Dear authors,

Thanks a lot for revising the manuscript. I still have major concerns, which have to be solved before the manuscript can be published. After modifications, I would like to look through the revised version.

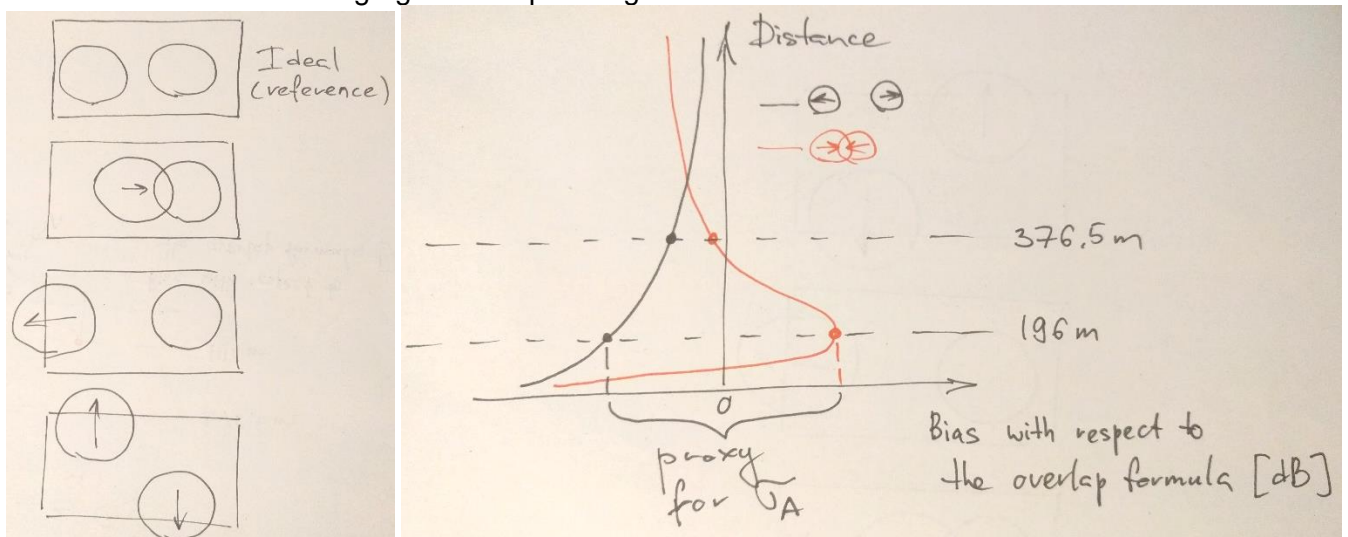
The assumption on parallel antennas can lead to large uncertainties. The problem with two antennas is that it is possible to measure the pattern of the receiving antenna with an external transmitter but it is often not possible to measure the transmitting antenna. Basically, with the proposed method only two points of the possible range dependent bias are characterized.

Instead of leaving this large uncertainty source untouched, I would encourage the authors to make a relatively simple estimation of possible impacts (just theoretical calculations, taking into account different divergences (magnitude and direction) of the two antennas and bias measurements at two distances). This would definitely improve the quality of the manuscript. The result of this theoretical estimation would give a proxy for σ_a in Eq. 6a which is currently, if I understand it right, completely neglected.

Just to better understanding I give a couple of figures:

On the left figure you can see different divergence directions. On the right figure I illustrate the impact (qualitatively). The authors could perform such calculations and give an estimate for σ_a (maximum divergence from 0 dB line).
